Re: Application No. NAPOP-R-80-0534-3  
Point Pleasant Pumping Station

Since submission of the referenced application on July 18, 1980, we have determined that certain revisions should be made in the plans for the project to improve the efficiency of the facility and to reduce to a minimum any environmental impact. These revisions are described in the following paragraphs and the reasons for each are given.

PUBLIC NOTICE

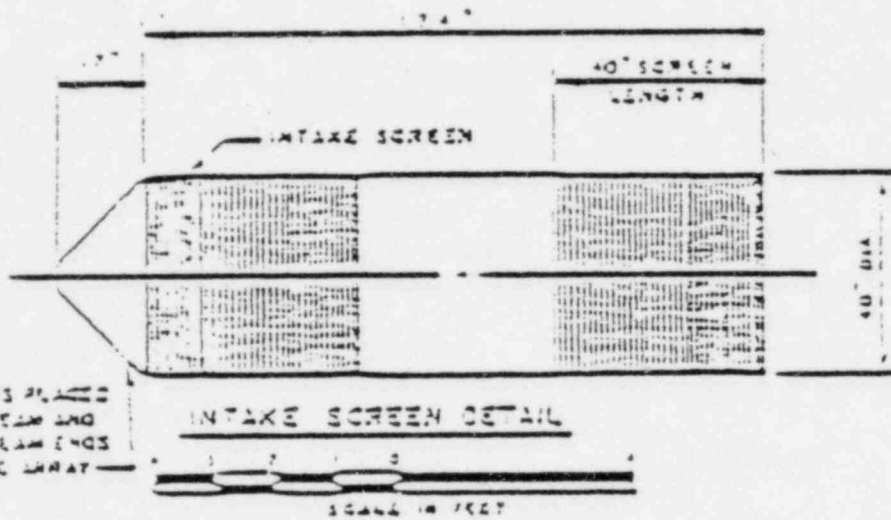
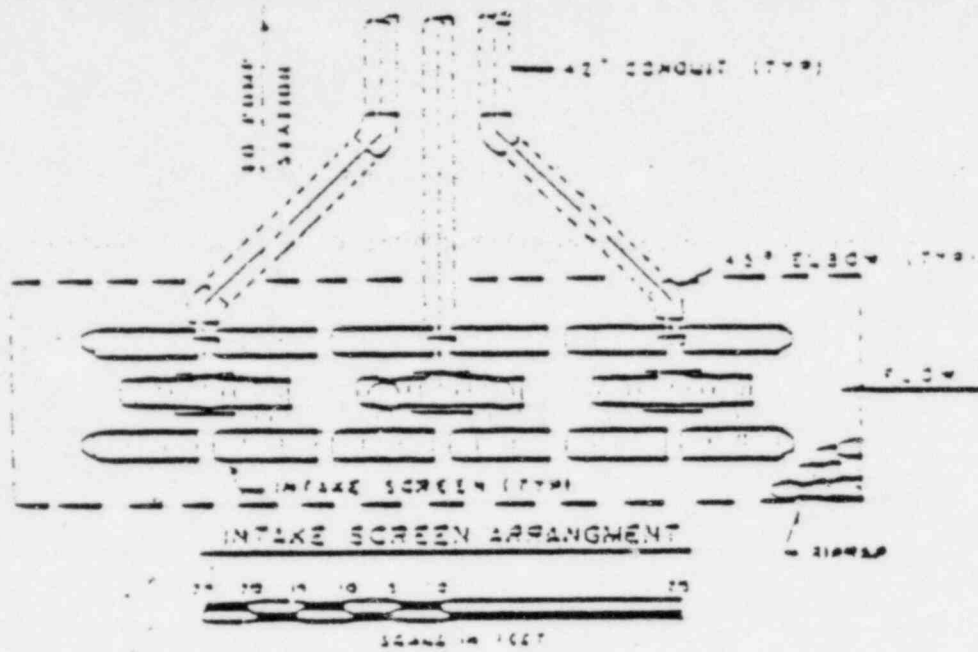
The applicant has made engineering revisions in its plans, as shown on the submitted drawings numbered 2-1 and 2-2 dated January 1982. The revisions in brief are:

1. Relocate the intake structure 45 feet further channelward in the Delaware River.
2. Place three intake pipes (42 inch diameter) under the Delaware River 6 feet apart instead of 22.5 feet apart.
3. Relocate the intake pipe crossing under the Pennsylvania Canal approximately 13 feet downstream, and increase the diameter of this pipe from 60 inches to 72 inches.
4. Lower the pump sump and the entire length of intake pipes from invert elevation 53.00 feet to invert elevation 53.73 feet.
5. Change the designation of the minimum water level elevation of the Delaware River from 68.0 feet to 70.0 feet.

The stated purpose for revisions 1 through 4 is to increase the operating efficiency of the water intake facility and to lessen any environmental impact. Revision number 5 reflects up to date hydrologic information and data. The purpose of the intake structure and its capacity are unchanged.

MESHAMINT WATER SUPPLY SYSTEM  
 POINT PLEASANT  
 PUMPING STATION  
 INTAKE SCREENS  
 PLUMSTEAD TOWNSHIP  
 BUCKS COUNTY, PENNSYLVANIA

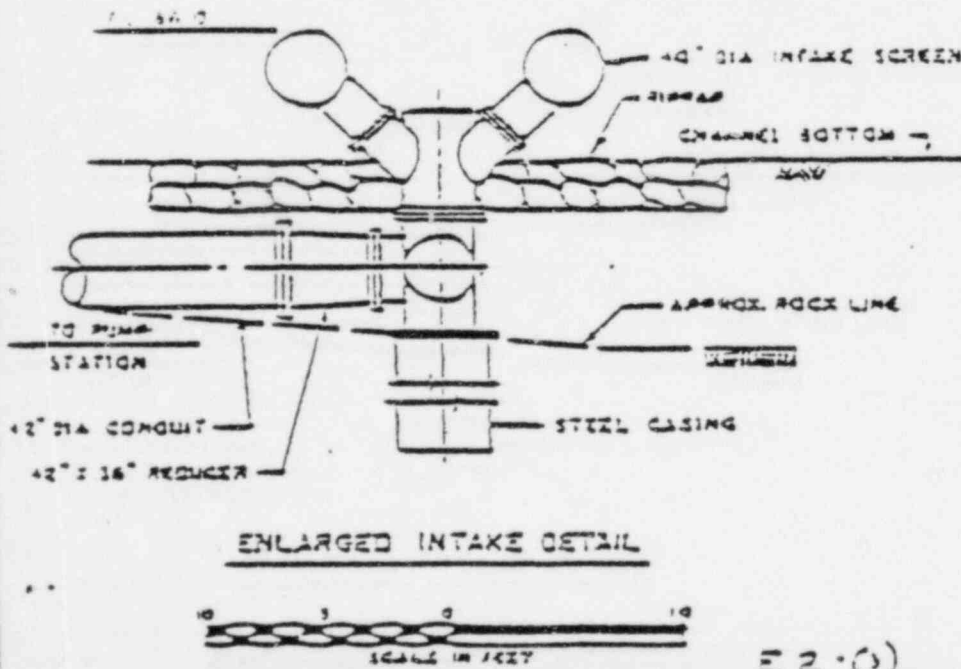
END CONES PLACED AT CENTER AND DOWNSTREAM ENDS OF INTAKE SCREEN

MINIMUM WATER LEVEL EL 70.0
